## **Access Compliance Report Public Rights-of-Way** (Curb Ramps)

Intersection ID: 49257 Main Street: BERRYBROOK\_LN Cross Street: SINGING\_OAK\_CT Location: ADA ID: AD21B072F489 Ramp Type: Perp Initial Pass/Fail: Fail **Overall Compliance: No** Severity Score: 26.25

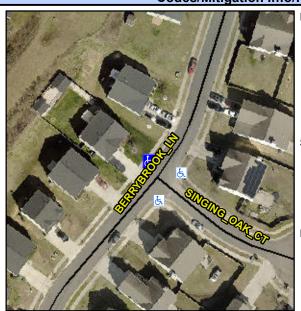
**BERRYBROOK LN** Street 1 Name Stop Condition-Street 2 None Street 2 Name N/A Stop Condition-Street 1 N/A Possible Solutions: Remove & Replace Entire Ramp. Surveyor Notes: N/A PROW/ADA: Not Found, R304.2.2, R304.5.3

Field Measurements/Component Compliance					
Compliance Description Da		Data	Comp	liance Description	Data
N/A	Ramp Length (in)	46.0	No	Ramp Slope (%)	20.0
Yes	Ramp Width (in)	50.0	No	Ramp XSlope (%)	3.1
N/A	Flare Type LT	N/A	N/A	Flare Type RT	N/A
N/A	Flare Slope LT (%)	N/A	N/A	Flare Slope RT (%)	N/A
N/A	Flare Traversable LT?	N/A	N/A	Flare Traversable RT?	N/A
N/A	Landing Length (in)	N/A	N/A	DWS Provided?	N/A
N/A	Landing Width (in)	N/A	N/A	DWS Contrast?	N/A
N/A	Landing Slope (%)	N/A	N/A	DWS Length (in)	N/A
N/A	Landing X Slope (%)	N/A	N/A	DWS Full Width?	N/A
N/A	Landing Curb? (Y/N)	N/A	N/A	DWS Offset (in)	N/A
N/A	Shared Landing?	N/A			
N/A	Gutter Ponding?	N/A	N/A	Gutter Slope (%)	N/A
N/A	Gutter Lip Ht (in)	N/A	N/A	Gutter X Slope (%)	N/A
N/A	Painted X Walk1?	No	N/A	Painted X Walk2?	N/A
	X Walk 1 Direction	To SE		X Walk 2 Direction	N/A
N/A	X Walk 1 Width (in)	N/A	N/A	X Walk 2 Width (in)	N/A
	X Walk 1 Slope (%)	3.1		X Walk 2 Slope (%)	N/A
